SUNDRY NOTICES AND REPORTS ON WELLS

8. Well Name and No.
PLU BIG SINKS 3 25 31 USA 1H 1H

BOPCO, L.P., respectfully requests to amend the approved eight point drilling program for the PLU Big Sinks 3 25 31 USA #1H to include a different casing string design. The change in design will allow for plug and perf operations instead of the open hole completion system initially proposed in the approved APD.
The relevant changed pages to the eight point drilling program are attached, as well as an updated wellhead diagram labeled "Diagram Z"

**** BLM REVISED ** BLM REVISED ** BLM REVISED ** BLM REVISED ** BLM REVISED ****

Diagram "Z"

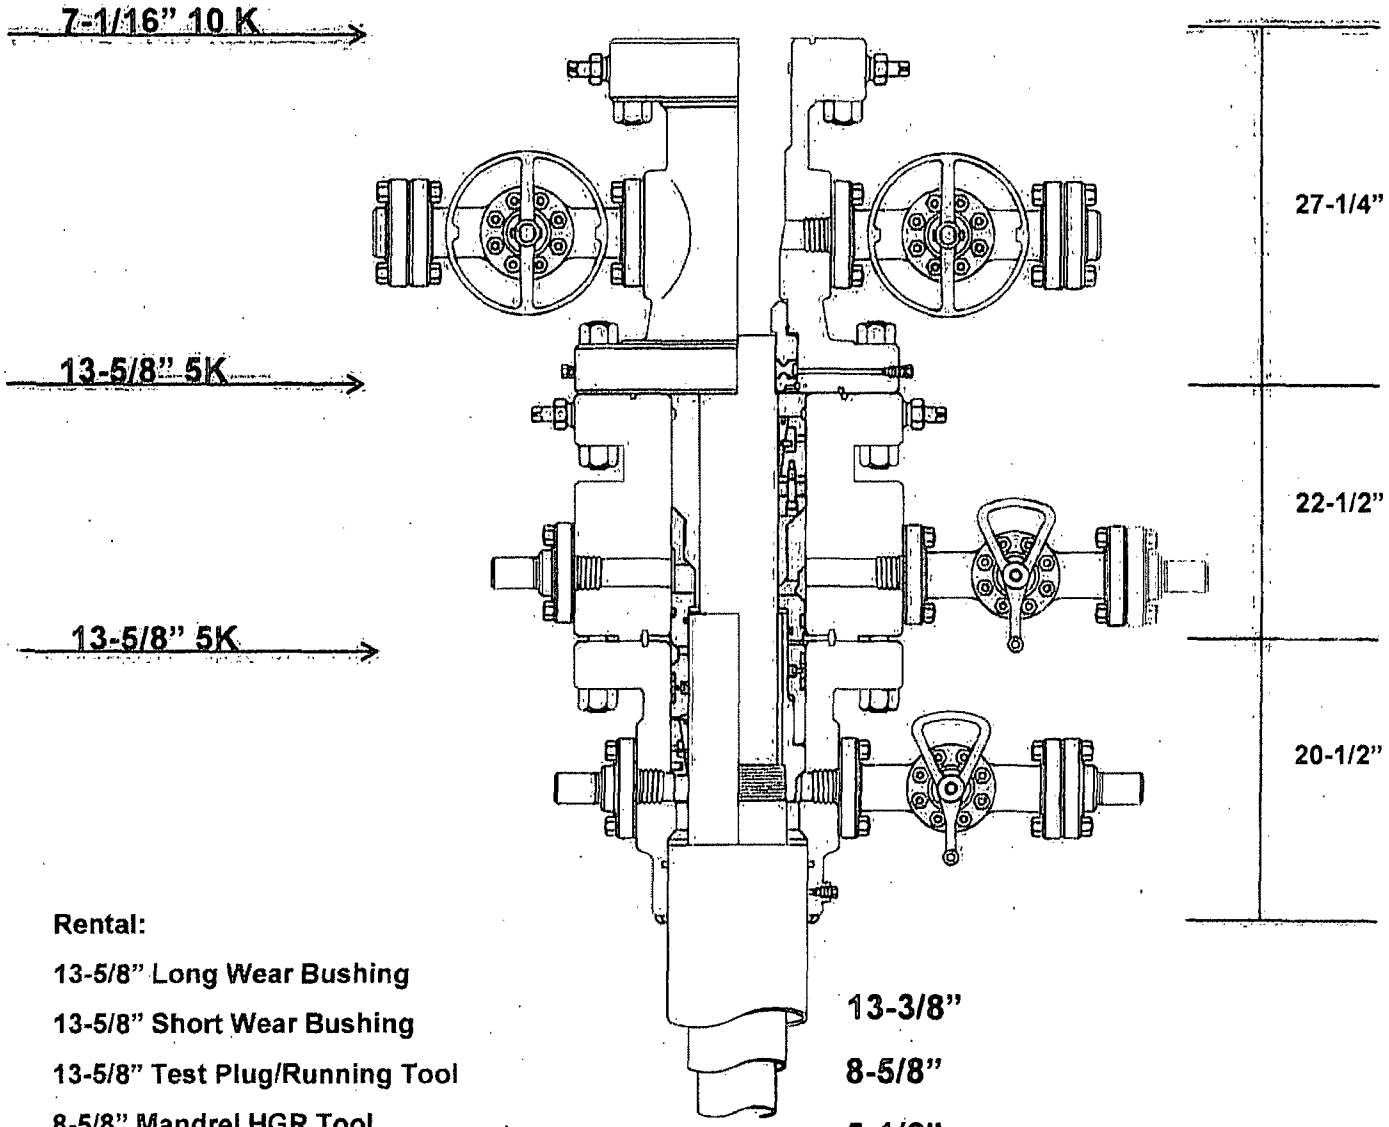
After running the 8 5/8' intermediate casing with a mandrel hanger, the 13 5/8" BOP/BOPE system with a minimum rating of 3M will already be installed on Cameron MBS. Please find attached the wellhead schematic.

3. **Operator has proposed a multi-bowl wellhead assembly. This assembly will only be tested when installed on the surface casing. Minimum working pressure of the blowout preventer (BOP) and related equipment (BOPE) required for drilling below the surface casing shoe shall be 3000 (3M) psi.**

a. **Wellhead shall be installed by manufacturer's representatives, submit documentation with subsequent sundry.**
    b. **If the welding is performed by a third party, the manufacturer's representative shall monitor the temperature to verify that it does not exceed the maximum temperature of the seal.**
    c. **Manufacturer representative shall install the test plug for the initial BOP test.**
    d. **Operator shall perform the intermediate casing integrity tests to 70% of the casing burst. This will test the multi-bowl seals.**
    e. **If the cement does not circulate and one inch operations would have been possible with a standard wellhead, the well head shall be cut off, cementing operations performed and another wellhead installed.**
